Project	<b>IEEE 802.16 Broadband Wireless Access Working Group</b> < <a href="http://ieee802.org/16">http://ieee802.org/16</a> >
Title	<b>Amendment to RSA Security Primitives in 14.2.2.2</b>
Date Submitted	<b>2007-03-1408</b>
Source(s)	Jung-Mo Moon, Jeehyeon Na, Mi-Young Yun, and Sangho Lee <a href="mailto:jhna@etri.re.kr">jhna@etri.re.kr</a> ETRI 161 Gajeong-dong, Yuseong-gu Daejeon 305-700 Korea
Re:	Contribution on comments to IEEE 802.16g/D8
Abstract	Re-definition of RSA primitives in section 14.2.2.2
Purpose	Adoption
Notice	This document has been prepared to assist IEEE 802.16. It is offered as a basis for discussion and is not binding on the contributing individual(s) or organization(s). The material in this document is subject to change in form and content after further study. The contributor(s) reserve(s) the right to add, amend or withdraw material contained herein.
Release	The contributor grants a free, irrevocable license to the IEEE to incorporate text contained in this contribution, and any modifications thereof, in the creation of an IEEE Standards publication; to copyright in the IEEE's name any IEEE Standards publication even though it may include portions of this co

Figure 474 – RSA based Authentication Procedure

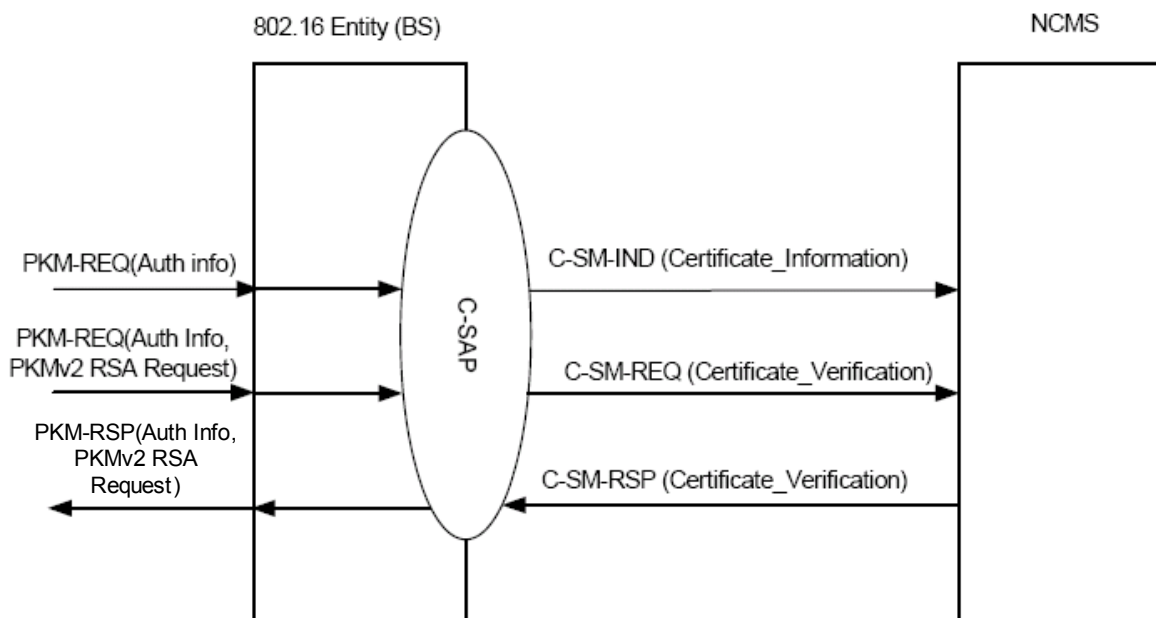
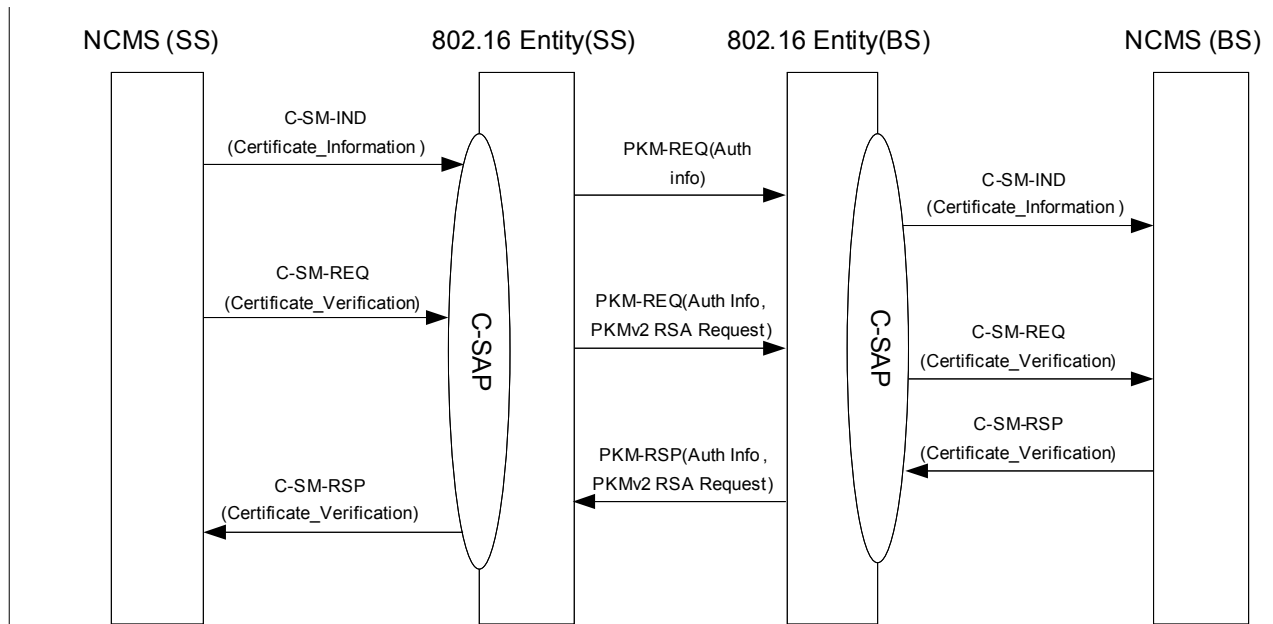
1. Modification of figure 474 which illustrate security primitives on the SS side.
2. Modification of each subsection to clarify and describes on each side (SS and BS side)

Figure 474 shows a RSA-based authentication procedure between an 802.16 entity a BS and ~~the~~ an NCMS on the MS side and the BS side entity as follows:
